April 29, 2020

**RE: Environmental Impact Statement, Fifteen Mile Stream Gold Project,
Highway 374, Trafalgar, Nova Scotia**

Physical environment considerations

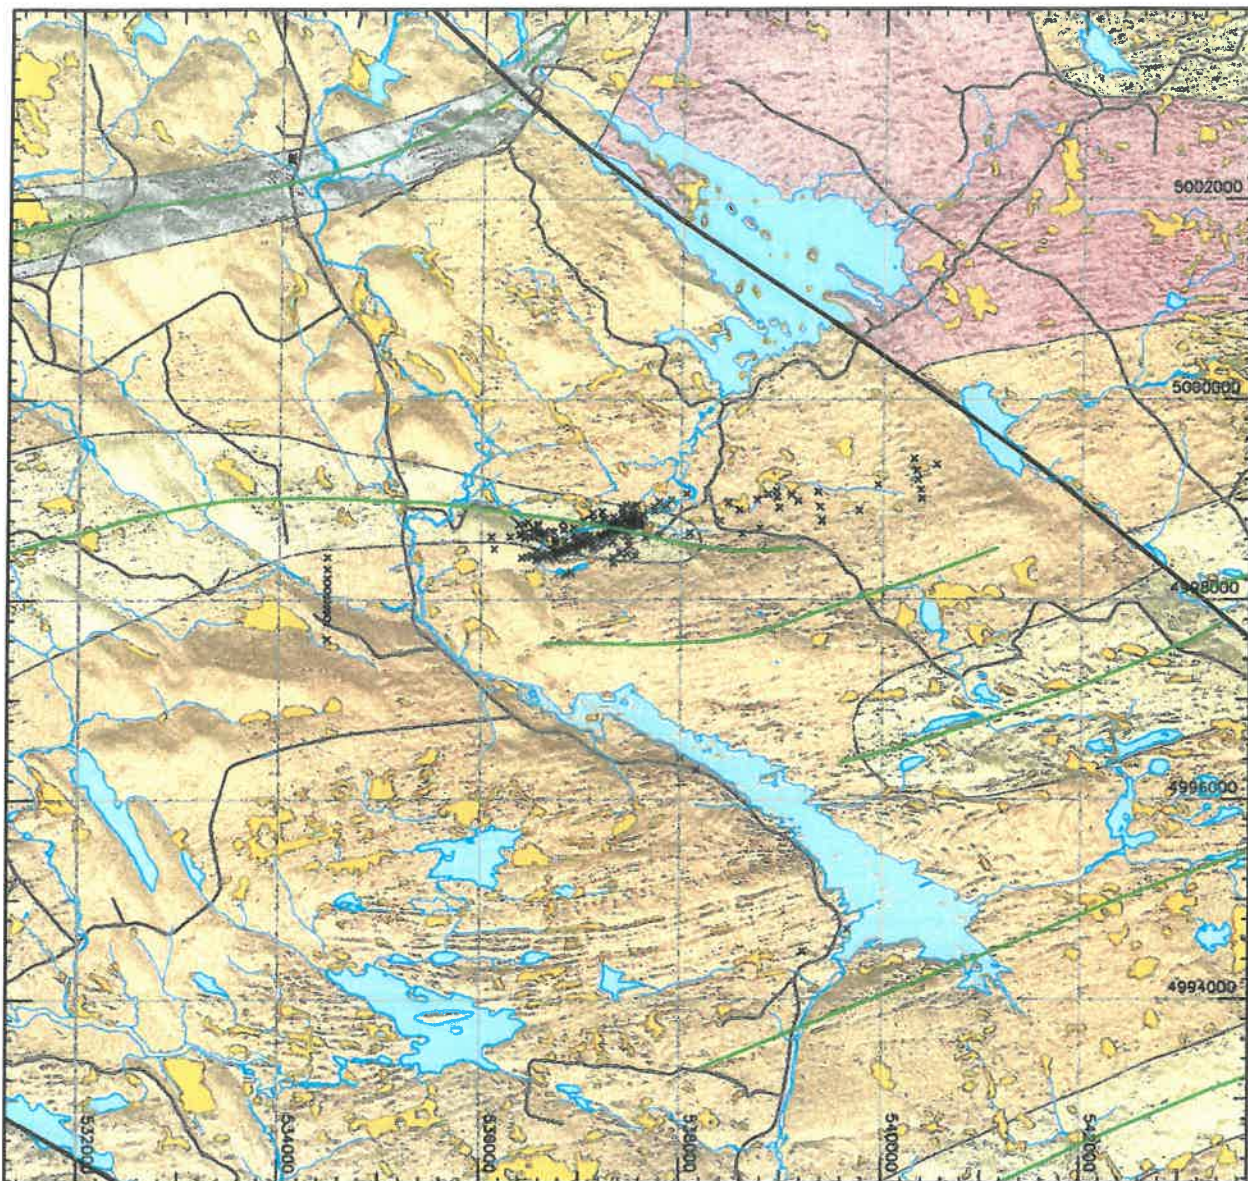
Further, the north-south section of Fifteen Mile Stream from near where the Seigel Fault Zone would be expected to intercept it (at the northwest to north bend in Route 374) northward about 4 km to the syncline and Beaverbank Formation mapped by White and Scallion (2011) appears to be controlled by a fault that may be synthetic (an adjustment) to the Bear Brook Anti Dam Flowage Fault. There are also a number of east-west brooks immediately to the north of the mine pit area and a few km south of it that parallel the Seigel Fault Zone.

Evidence for the faults and suspected fault zones noted above based on lineaments is apparent in all of maps in the EIS that show topographic and surface water features, in Campbell (1988), in White and Scallion (2011), and in the shaded relief image in Figure 1. The easterly extension of the Seigel Fault Zone is suggested by the faulting noted in drillholes by Campbell (1988), and the westerly extension of it is suggested by the severe faulting noted in drillholes by Richardson and Terry (1988) and their cross section in Figure 2.
